**SECTION 00 90 03
BIDDING AND CONTRACT REQUIREMENTS
ADDENDUM NUMBER 3**

Issued: March 13, 2025

**McHenry County College
2024 Health Science Renovations**
Architect's Project Number: 24-032

2 REFLECTED CEILING PLAN - LEVEL 1 - RADIOLOGY
 3/16" = 1'-0"
 TRUE NORTH

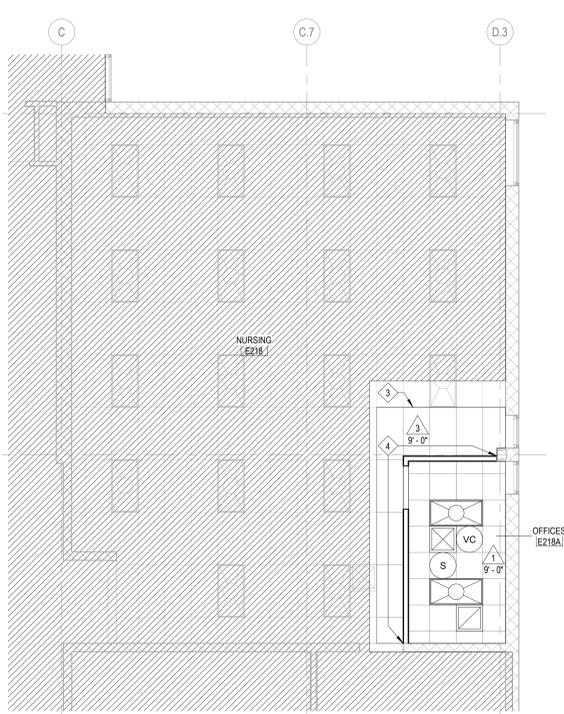
1. A2.10
 - A. **ADD** new roller shades to RCP for Radiology Suite at existing exterior windows.
2. A9.51
 - A. **REVISE** detail 4 to indicate correct p-lam base cabinet finish.
 - B. **REVISE** detail 9 to indicate correct p-lam countertop finish.
 - C. **REVISE** detail 7 and 8 to indicate solid wood edge at interior wall.
 - D. **REVISE** detail 8 to remove note “both sides” for SS End Panel.
 - E. **REVISE** finish legend as indicated.

- A. RESPONSE: D427-60 is listed for PL-3, Wilsonart Linen. Paloma Polar 6698 is listed for PL-2. Both should be provided with a Matte Finish.
18. Pre-Bid RFI #18 - As per RCP- Level 1- Radiology, note C3 to remove existing blinds are called out at a few locations. Please confirm if new blinds are to be provided at any of those locations?

- A. RESPONSE: Roller shades should be provided at all exterior windows in Radiology Suite. Refer to updated A2.10 for scope.

4 MILLWORK ELEVATION - X-RAY ROOM
 1/2" = 1'-0"

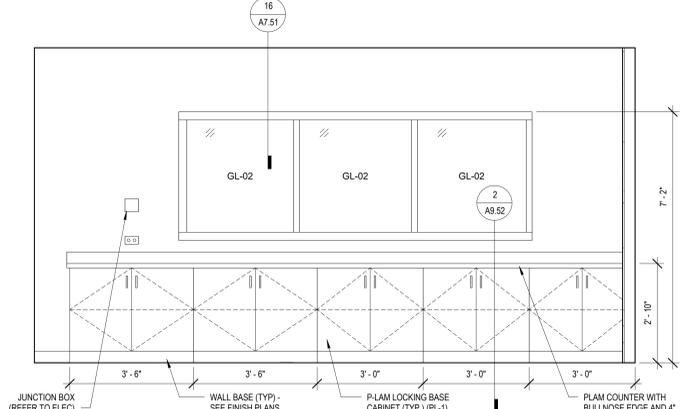
11. Pre-Bid RFI #11 – 4/A9.51 is calling out PL-1 base cabinets on the left, and PL-2 base cabinets on the right. I'm assuming it is all PL-1. Please clarify.

- A. RESPONSE: The base cabinets should be PL-1.
12. Pre-Bid RFI #12 – 9/A9.51 is calling out a PL-1 countertop, and 10, 11/ A9.51 are calling out PL-2 countertop. I'm assuming it is PL-2. Please clarify.

8 MILLWORK ELEVATION - RADIOLOGY SUITE
 1/2" = 1'-0"

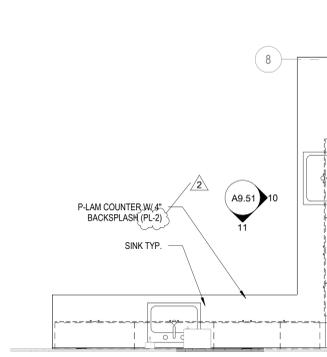
- A. RESPONSE: WD-1 and WD-2 are the correct solid / veneer wood types for this section.
14. Pre-Bid RFI #14 – 8/A9.51 is calling out 1.25" Solid Surface End Panel Both Sides. The drawings show 1 waterfall leg. 11/ A9.01 shows the other side of the die wall is perpendicular to a wall. Do they want an inside solid surface waterfall face descending from the countertop to the floor on the inside wall? Please clarify.

- A. RESPONSE: No waterfall edge is required at the interior wall.
15. Pre-Bid RFI #15 – 5/A9.51 is not referred to on the plans. I am assuming it is the opposite the 4/A9.51 elevation tag on the (east) side of the wall on 3/A9.51. Please clarify.

A9.52

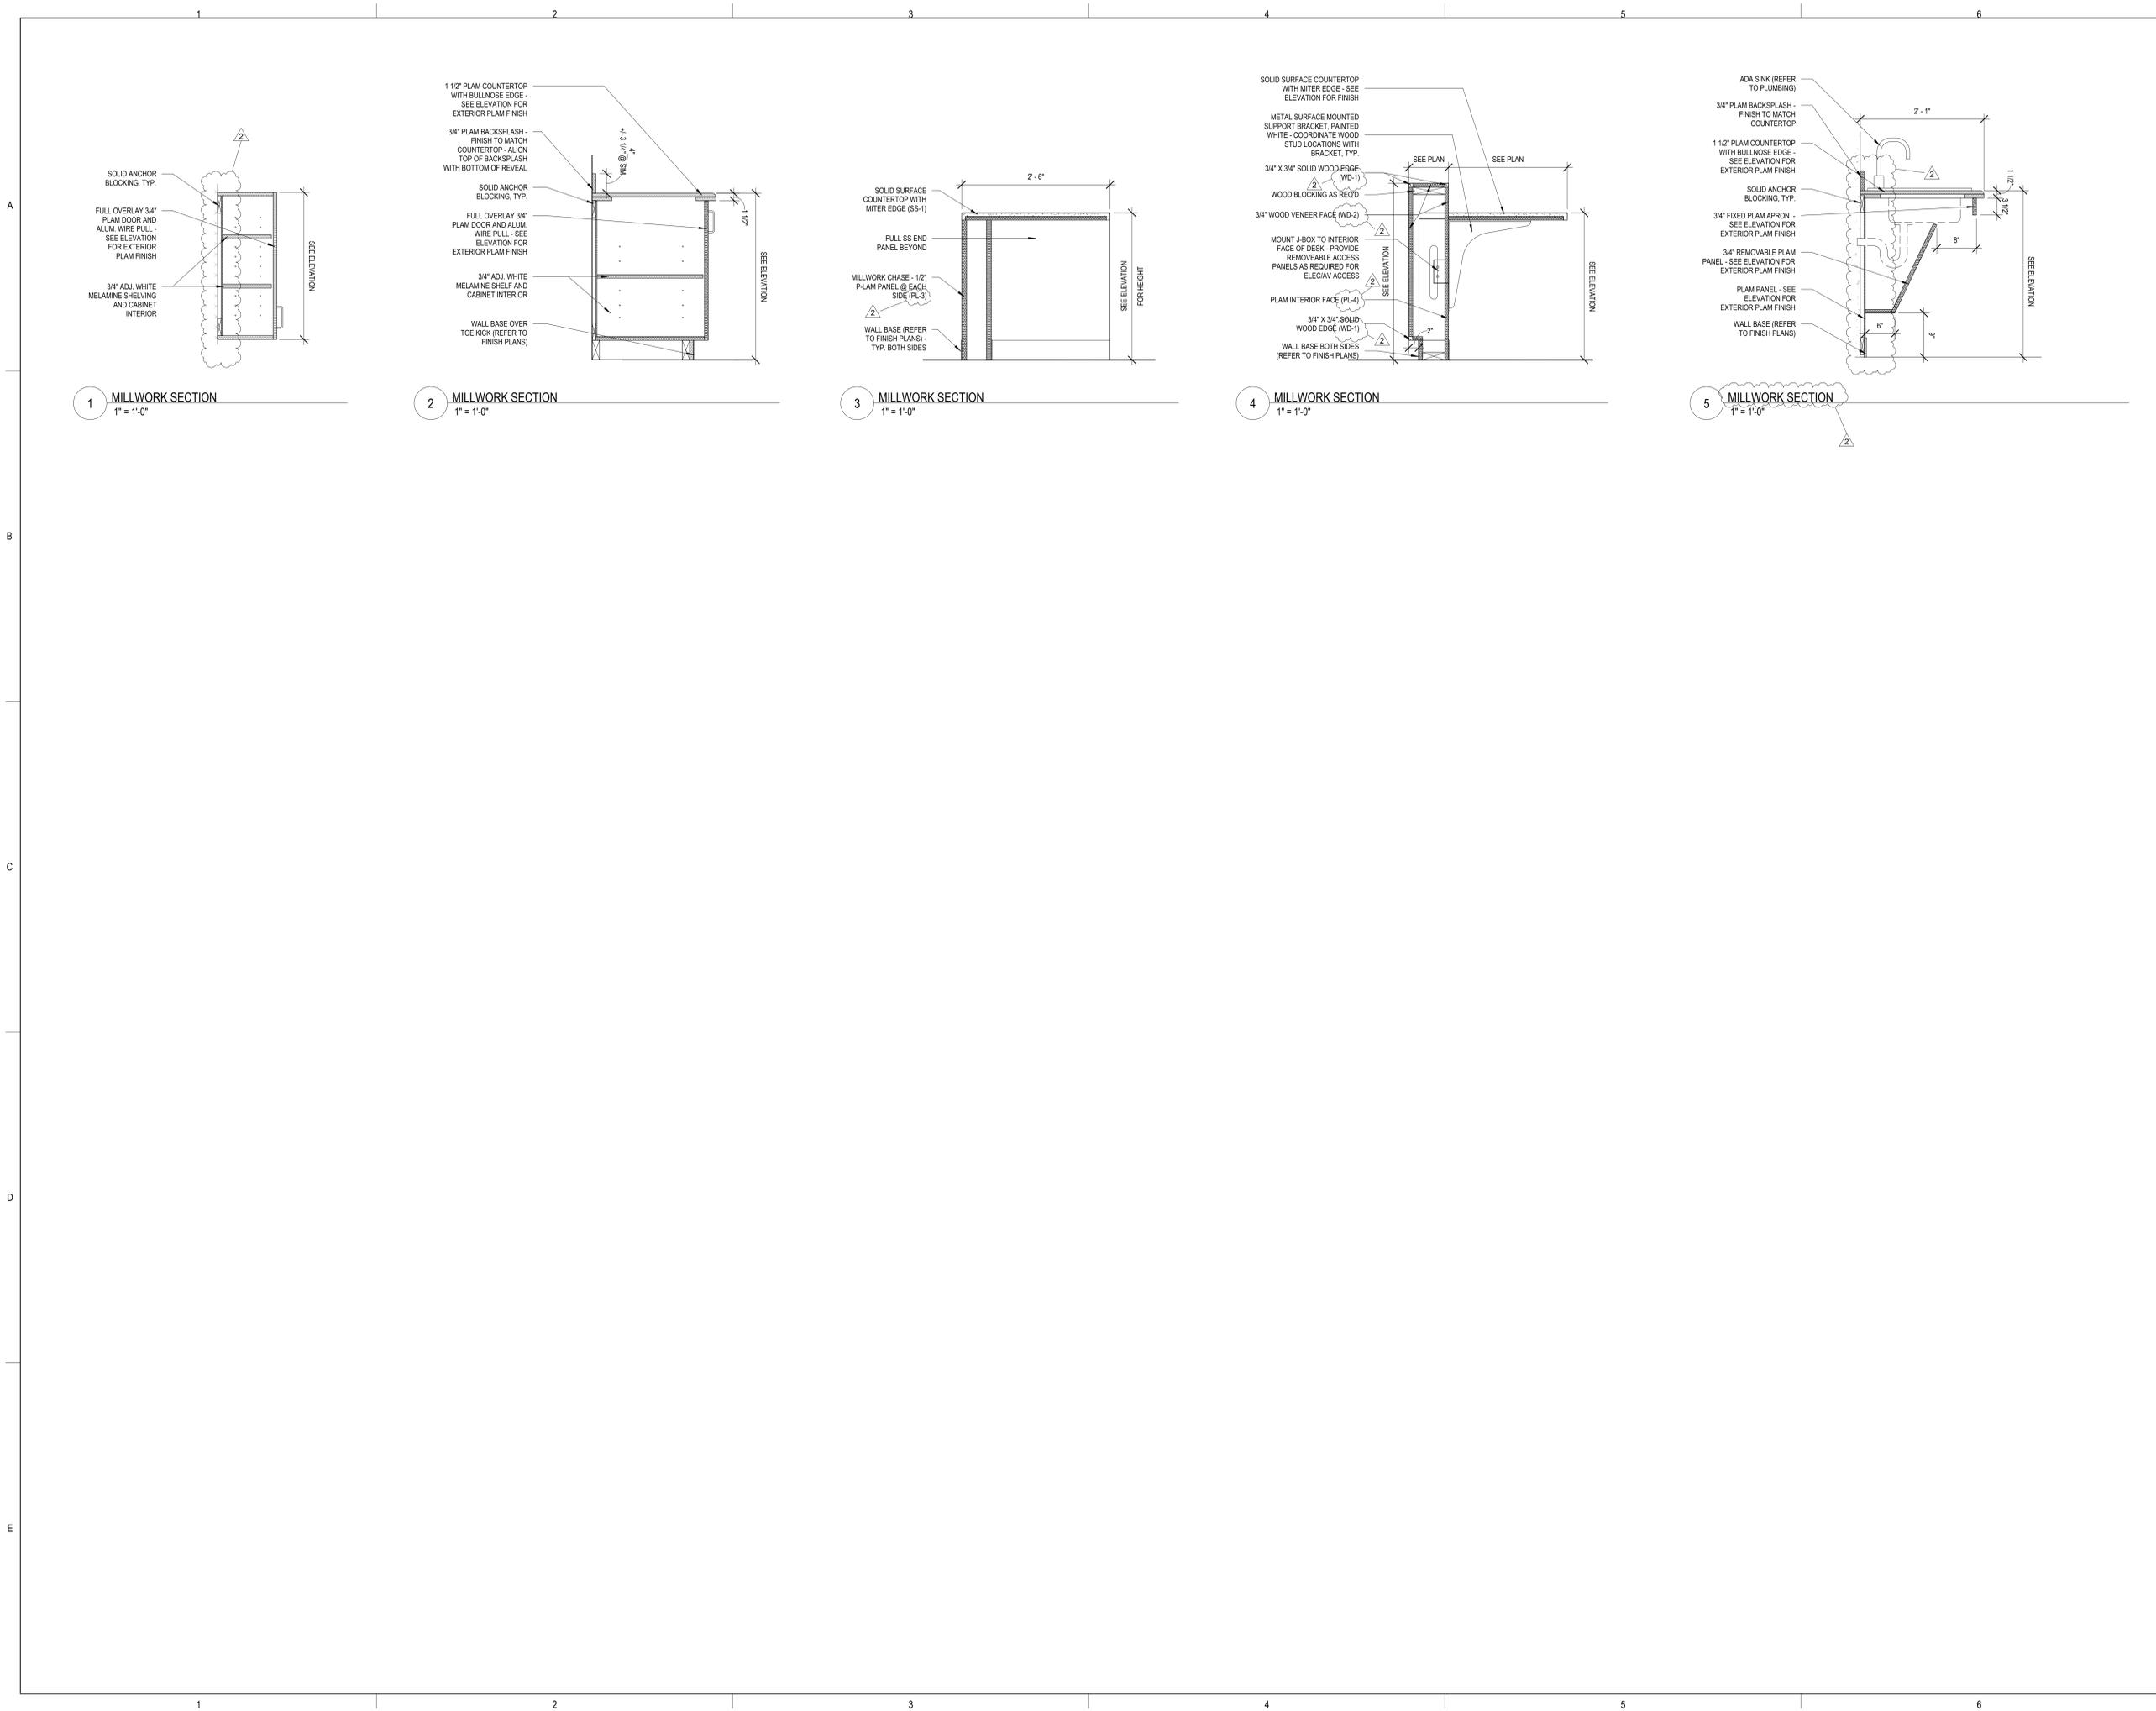
3. A9.52
 - A. **REVISE** details 1 and 5 as indicated to clean up overlapping lines and mis-labeled sections.
 - B. **REVISE** detail 3 to indicate correct p-lam finish.
 - C. **REVISE** detail 4 to correct wood finish types.
4. A10.00
 - A. **ADD** door hardware sets as indicated to the door schedule.

- A. RESPONSE: The countertop should be PL-2.
13. Pre-Bid RFI #13 – 4/A9.52 is calling WD-5 & WD-6 which are not on the finish schedule. I am assuming they are WD-1 & WD-2. Please clarify.
